To: Bidders for the *Oak Brook Park District- Central Park Improvements*

SUBJECT: ADDENDUM NO. 1 TO THE BIDDING DOCUMENTS FOR:
Oak Brook Park District – Central Park Improvements
Bid Group #1 Bid Packages 1 - 19

Project No. 07-5646-04

QUESTIONS AND ANSWER LOG

3 WOOD ENCLOSURE - SECTION
 1/2" = 1'-0"

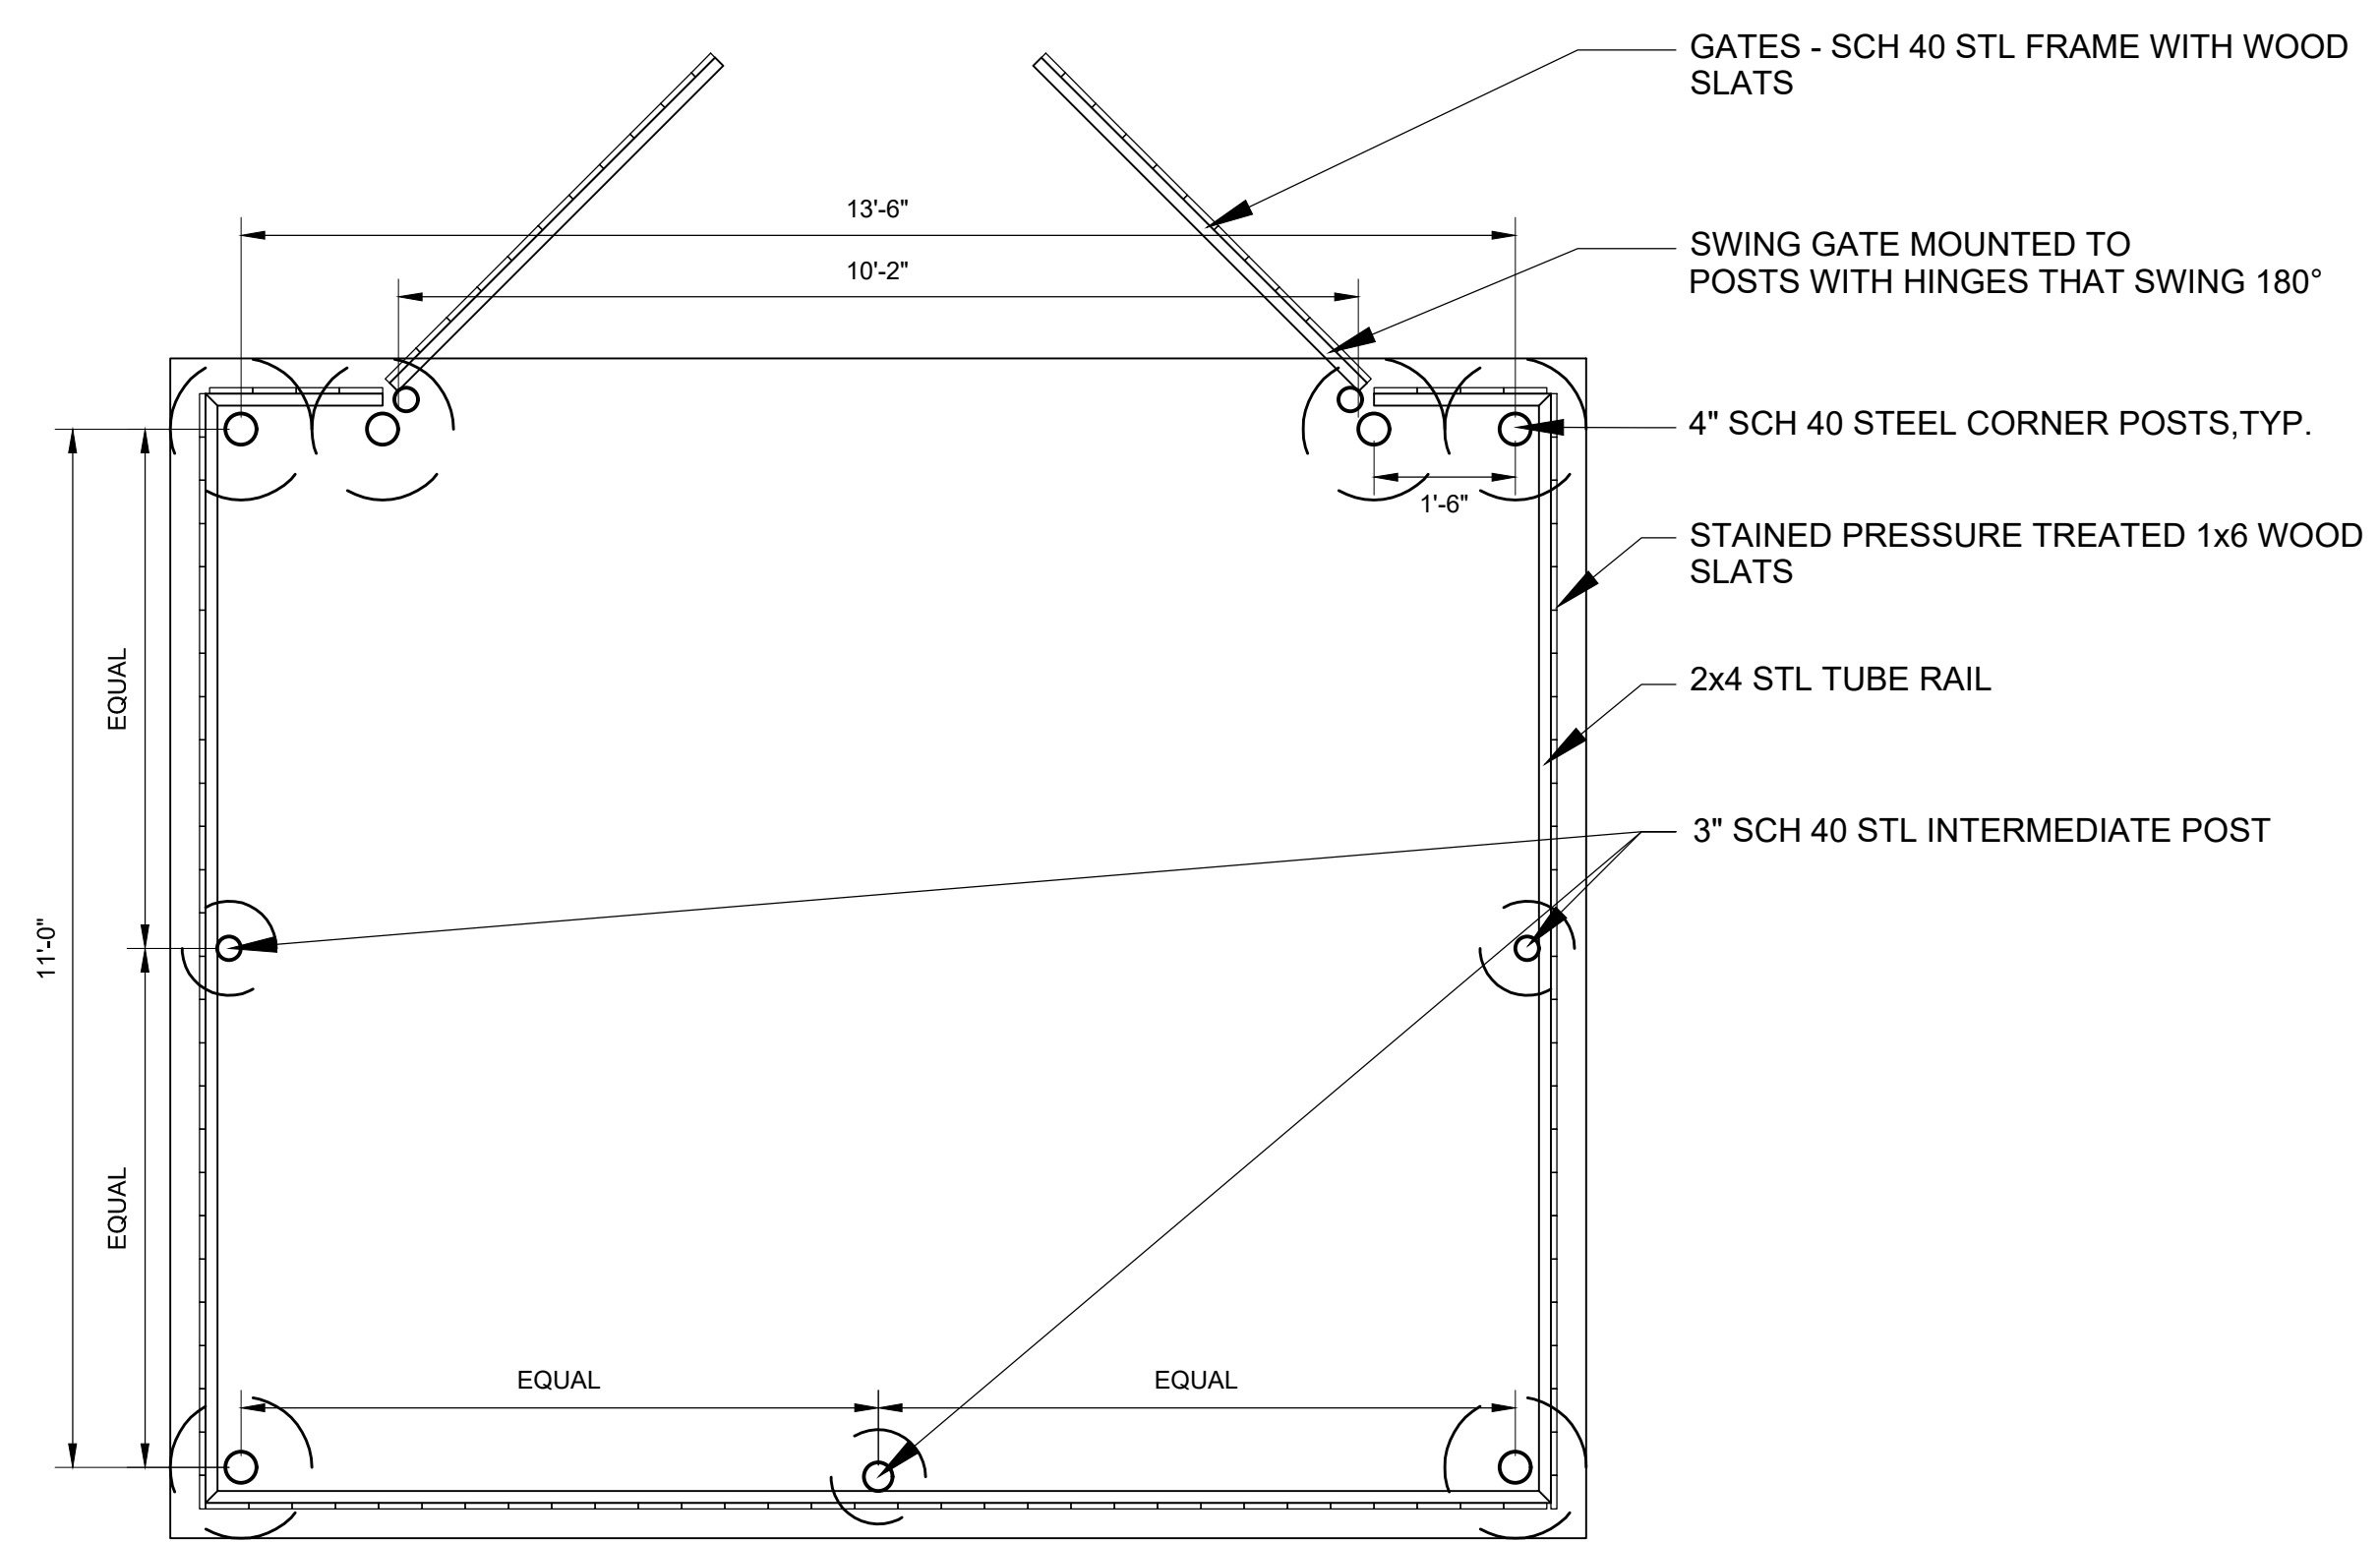
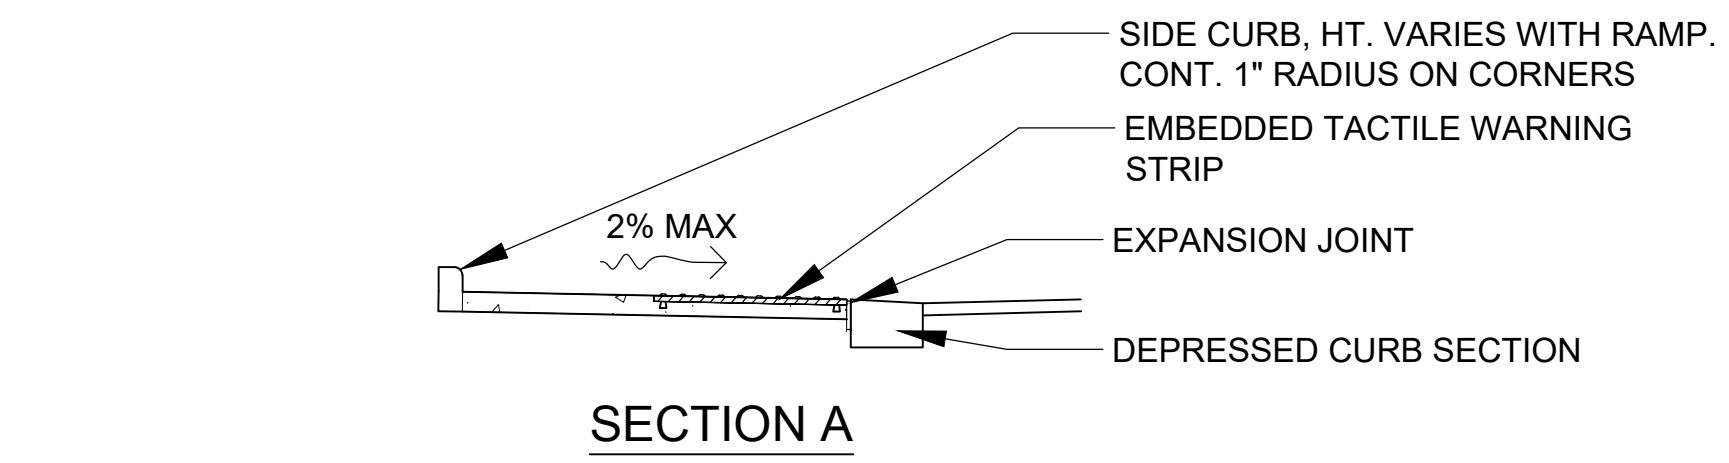
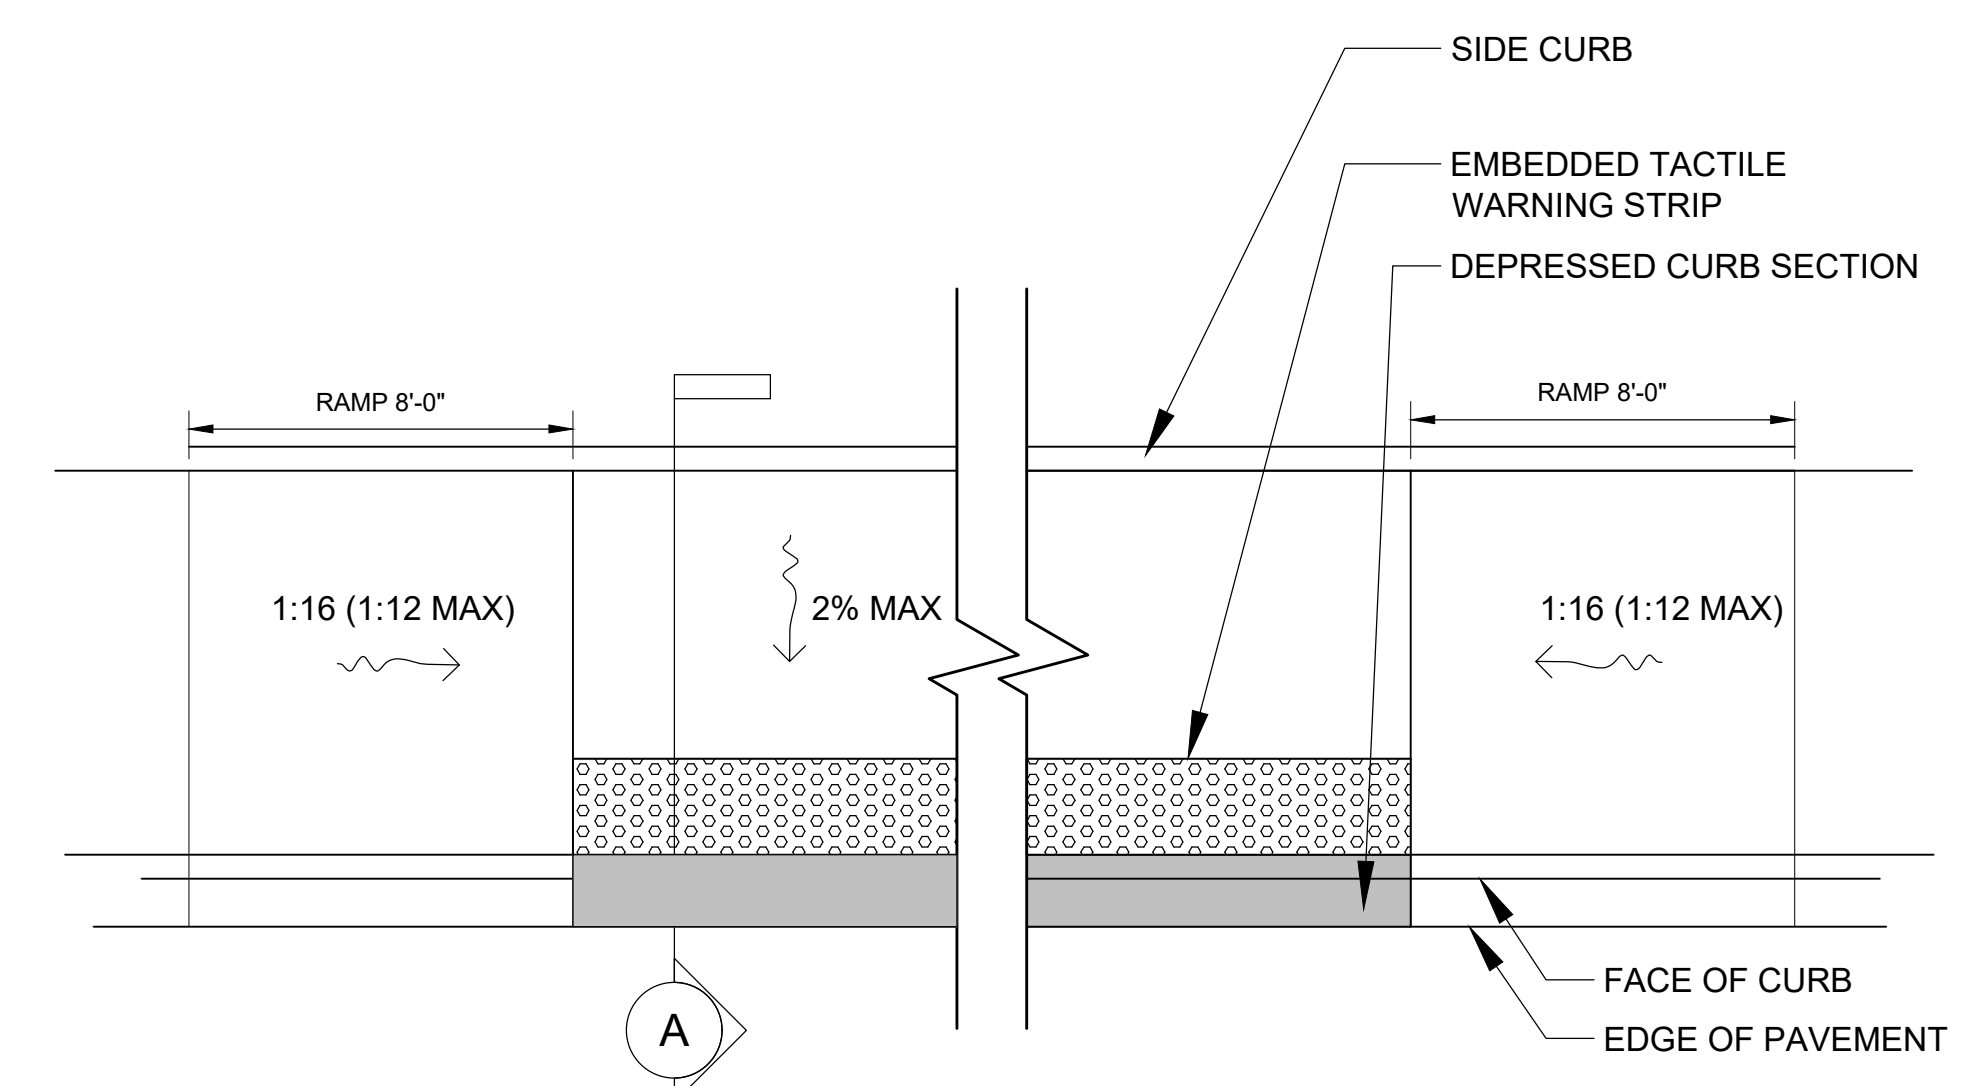
8. SD4.07 – Detail sheet added with wood enclosure and accessible curb ramp.
9. SD4.08 Detail Sheet added for specific Permeable Paver BMP #1 area located at the north parking lot. Contractor to slope subgrade as specified and verify BMP Volume required per County Code with as-built topo survey.
10. SD4.09 Detail Sheet added with the following details: 2' Inlet, 3' Catch Basin/Inlet, Curb Cut Detail and Nyloplast Drain Basin Detail.

#	Questions	Answers
1	Please provide fence details for the wooden trash enclosure fence and gates.	Fence details have been provided with this addendum
2	Please advise if the ornamental fence as detailed on drawing SD4.02 is part of the fence bid package. On drawing SD2.04 shows the ornamental fence layout. one of the notes on the north side says "By others".	The ornamental fence is part of the bid package 'By Others' has been removed.
3	Specification section 323113-6,2.6C. custom barrier net. Reference order #0285282. The manufacturer quoted this with steel poles. Detail #8 on drawing SD4.05 calls for 4" o.d. aluminum poles with ground sleeves. The manufactures is asking the following questions: 1. Are the poles aluminum or steel? 2. Do you want the poles to be permanently set or in ground sleeves? 3. Are the nets to be permanently installed or with hoisting ropes?	1. Poles will be steel. 2. Poles will be permanently embedded. 3. Nets will be installed with hoisting ropes.
